# Access Compliance Report Public Rights-of-Way (Curb Ramps)

Intersection ID: 10029691	Main Street: KINGSLEY_VIEW_DR	Cross Street: N/A	Location: SW
ADA ID: 82274787CCAF	Ramp Type: BlendTrans1	Initial Pass/Fail: Fail	Overall Compliance: No Severity Score: 18.75

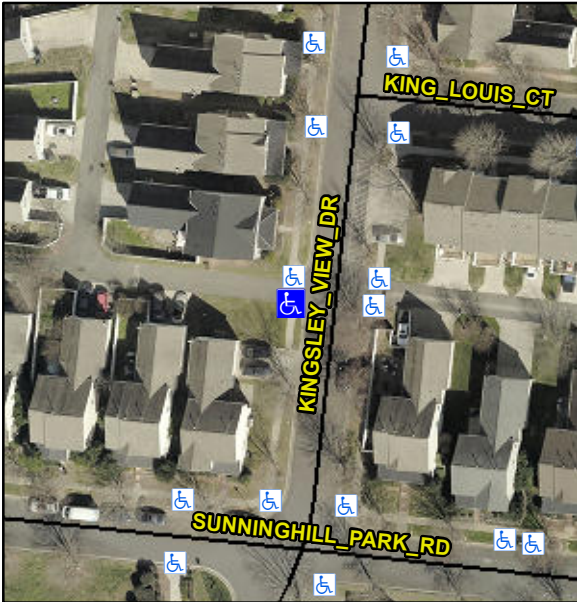
PROW/ADA:  
**Not Found, R304.5.1, R304.5.3**

Compliance	Description	Data	Compliance	Description	Data
N/A	Ramp Length (in)	66.0	Yes	BlendTrans Slope (%)	2.5
No	Ramp Width (in)	35.0	No	BlendTrans XSlope (%)	2.4
N/A	Flare Type LT	N/A	N/A	Flare Type RT	N/A
N/A	Flare Slope LT (%)	N/A	N/A	Flare Slope RT (%)	N/A
N/A	Flare Traversable LT?	N/A	N/A	Flare Traversable RT?	N/A
N/A	Landing Length (in)	N/A	N/A	DWS Provided?	N/A
N/A	Landing Width (in)	N/A	N/A	DWS Contrast?	N/A
N/A	Landing Slope (%)	N/A	N/A	DWS Length (in)	N/A
N/A	Landing X Slope (%)	N/A	N/A	DWS Full Width?	N/A
N/A	Landing Curb? (Y/N)	N/A	N/A	DWS Offset (in)	N/A
N/A	Shared Landing?	N/A			
N/A	Gutter Ponding?	N/A	N/A	Gutter Slope (%)	N/A
N/A	Gutter Lip Ht (in)	N/A	N/A	Gutter X Slope (%)	N/A
N/A	Painted X Walk1?	No	N/A	Painted X Walk2?	No
	X Walk 1 Direction	To E		X Walk 2 Direction	To N
	X Walk 1 Width (in)	N/A		X Walk 2 Width (in)	N/A
	X Walk 1 Slope (%)	1.0		X Walk 2 Slope (%)	1.5
	X Walk 1 X Slope (%)	0.7		X Walk 2 X Slope (%)	0.4

N/A	Ramp inside XWalk1?	N/A	N/A	Ramp inside XWalk2?	N/A
	Road Slope (%)	2.0		Clear Space?	N/A
	Road X Slope (%)	1.1	N/A	Clear Space to XWalk (in)	N/A
N/A	Any Obstructions?	N/A	N/A	Storm Grate/Utility Hazard?	N/A
	Obstruction Type			Storm Grate/Utility Type	
		N/A			N/A
Yes	Surface Condition? (G/P)		Yes		Good
No	Curb Slope (%)		No		9.7

Possible Solutions:  
**Remove & Replace Curb Ramp With Two New Directional Ramps or Equivalent.**
